BIDDING ADDENDUM NO. 1

TO THE DRAWINGS AND PROJECT MANUAL
FOR THE CONSTRUCTION OF THE
ROOF REPLACEMENT

ROBERT JOLLEY BUILDING
101 S. MAIN STREET
CLINTON, TENNESSEE 37716

DECEMBER 10, 2018

(A) ANTENNA SUPPORT AT PENTHOUSE "B"

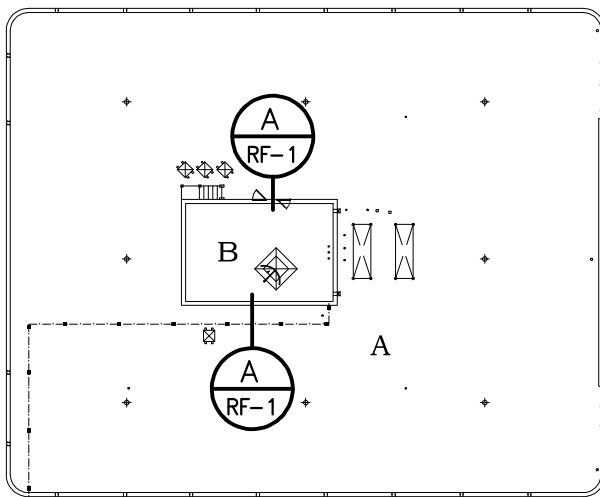
1. Insert Detail RF-1: This detail is to be used for the radio and/or communication antennas support bracket attachment to the parapet wall at Penthouse Roof Area "B".
